UNC 0645S:

Amending the oxygen content limit in the Network Entry Agreement at South Hook LNG

- 01 Modification
- 02 Workgroup Report
- 03 Draft Modification Report
- 04 Final Modification Report

Figure 1: 'Heat Map' – Milford Haven maximum flows during winter conditions.

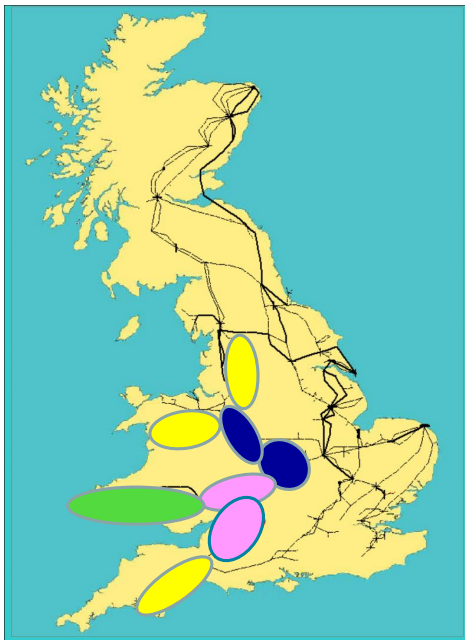
All storage sites are generally assumed to be withdrawing based on the FES forecasts. Provided this is the case, those in the North-West would not be adversely affected even if South Hook gas penetrated that far into the network.

Network analysis results indicate up to ~25% of Milford Haven gas is observed to move up to the North-West, potentially equating to up to ~50ppm of oxygen content in that region. Please see Figure 1 for a diagram of the heat map analysis for Winter demand. ~~of the four heat maps provided, this effectively is a worst case scenario.~~

Figure 4: 'Heat Map' of NTS during summer conditions with maximum range of Milford Haven gas.

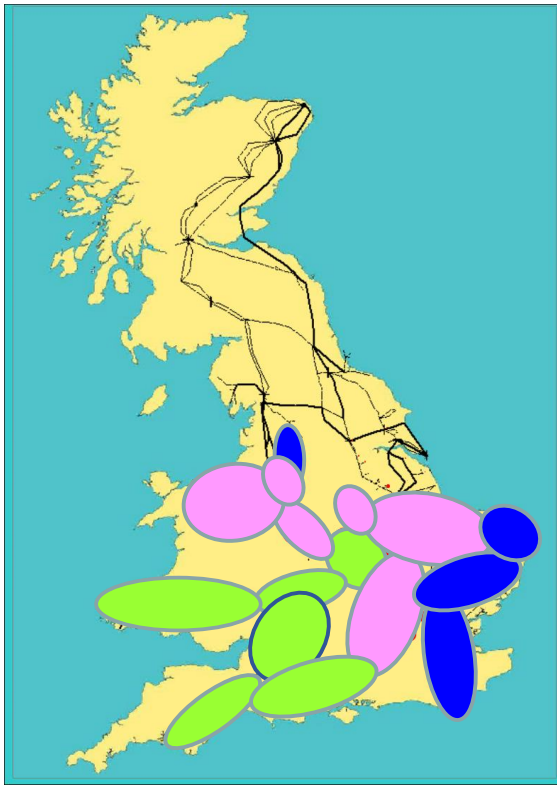
High case inputs from South Hook along with low NTS demand conditions leads to a significant proportion of South Hook gas penetrating up to the North West, leading to the potential for up to ~150 ppm of oxygen content in the region. This is shown in Figure 4.

An increase in the oxygen content of gas entering gas storage facilities, could require them to incur gas processing costs in order to prevent the additional oxygen entering the system (which could otherwise lead to corrosion). National Grid "heatmap" analysis has highlighted the potential, under credible scenarios, for South Hook gas to flow into the North-West of England, thereby potentially affecting all NW gas storage (which includes Uniper's Holford Gas Storage Site).
